406 ENGINEERING

April 5, 2024

RE: Aspire Subdivision, Annexation, & Zoning Upon Annexation 2nd Sufficiency Review

LOTS 1-5
ASPIRE SUBDIVISION
SEC. 19, T.13N, R.18W, AND
SEC. 24, T.13N, R.19W, P.M.M.
MISSOULA COUNTY, MONTANA

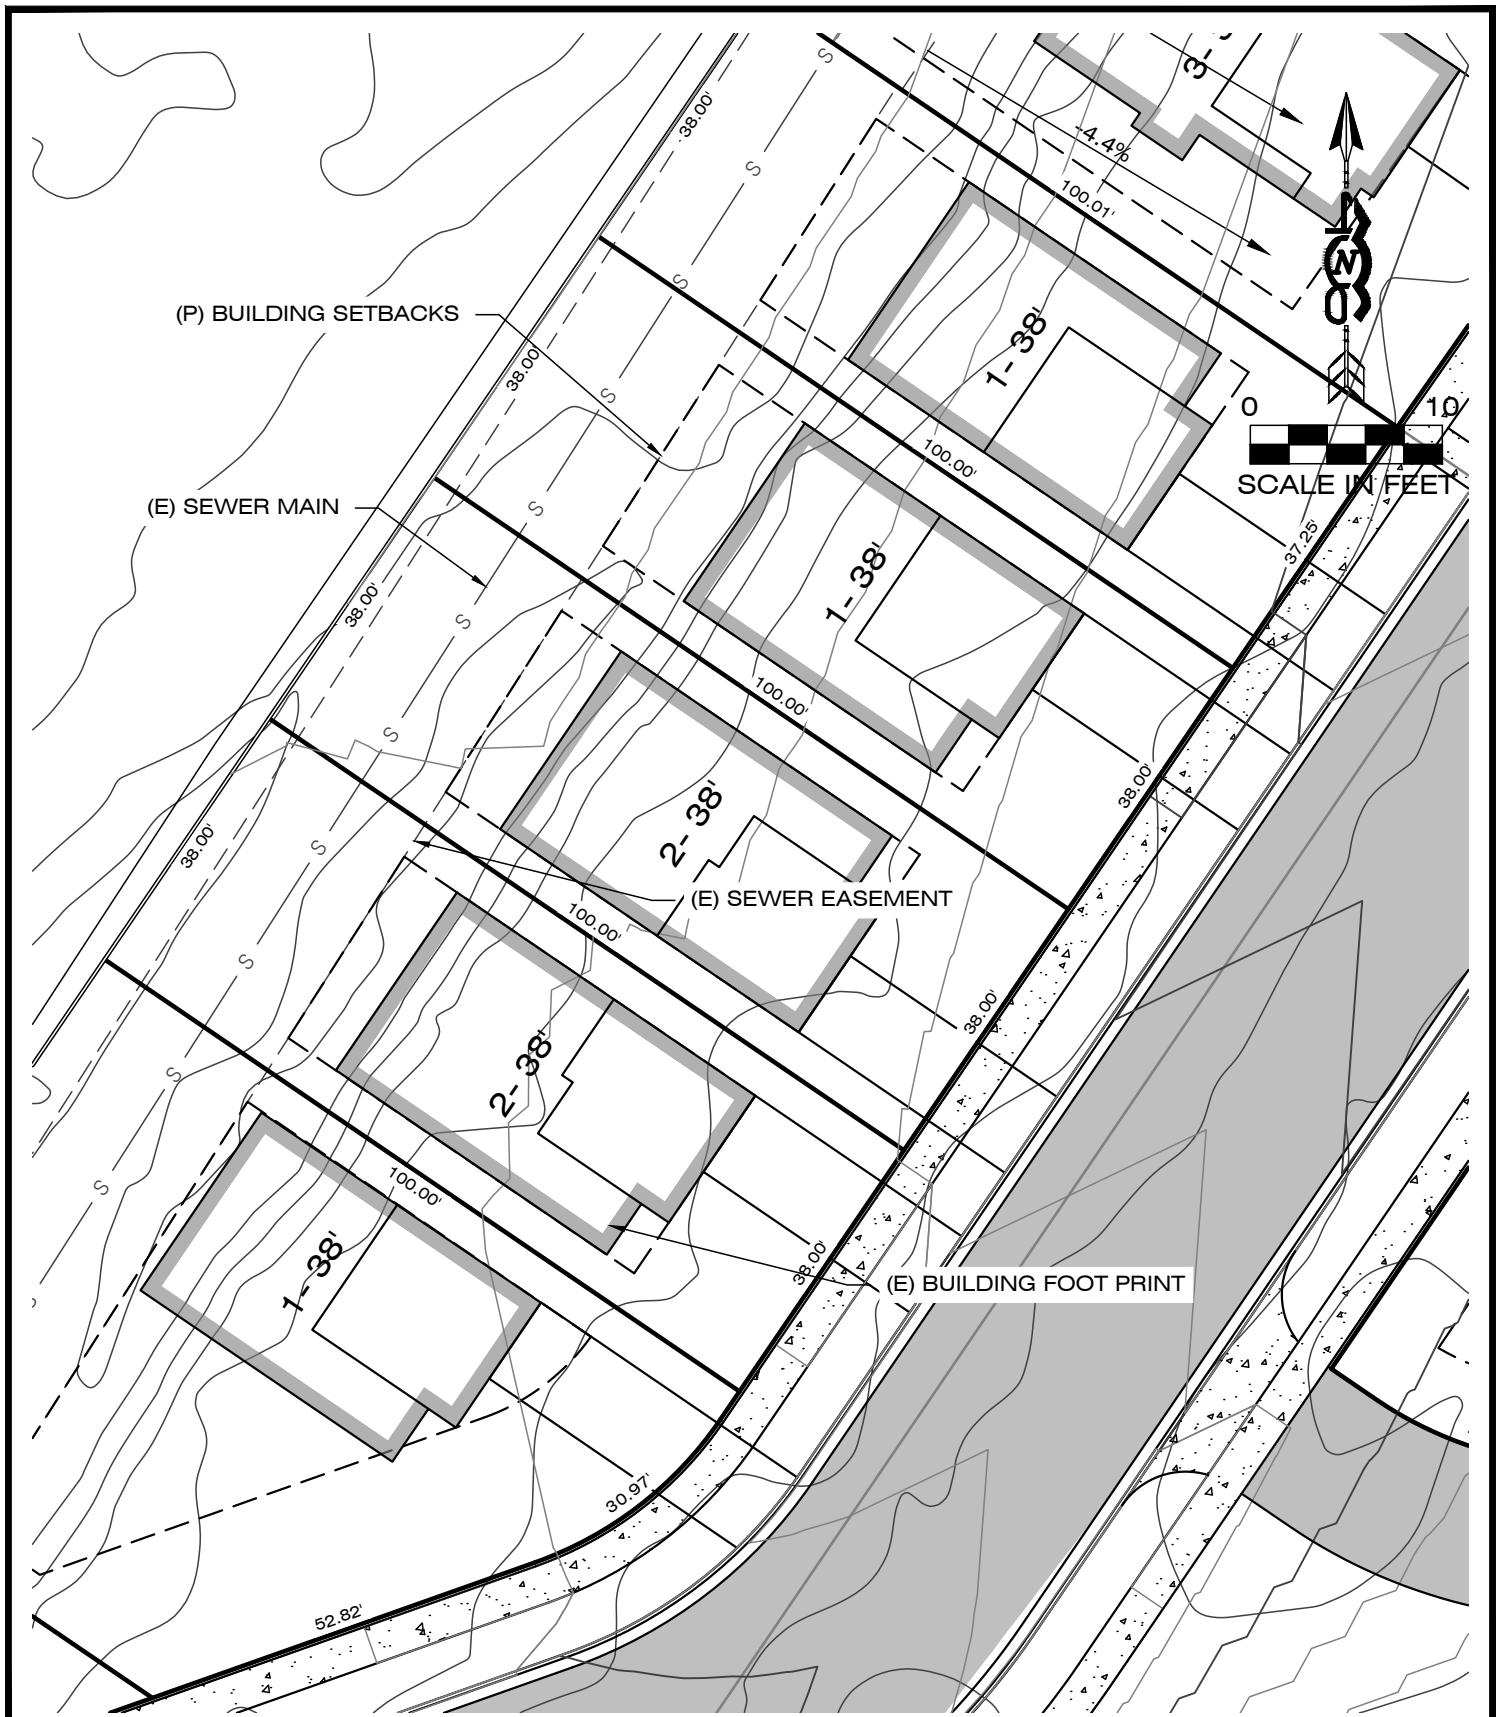
18. *Confirm Lots 1-5 are buildable with the existing sewer main easement. (Required for sufficiency) (MCPWSS 5.2.7)*

Attached is an exhibit showing the outline of the proposed home for Lots 1-5 showing the constructability of each lot. (See Attachment)
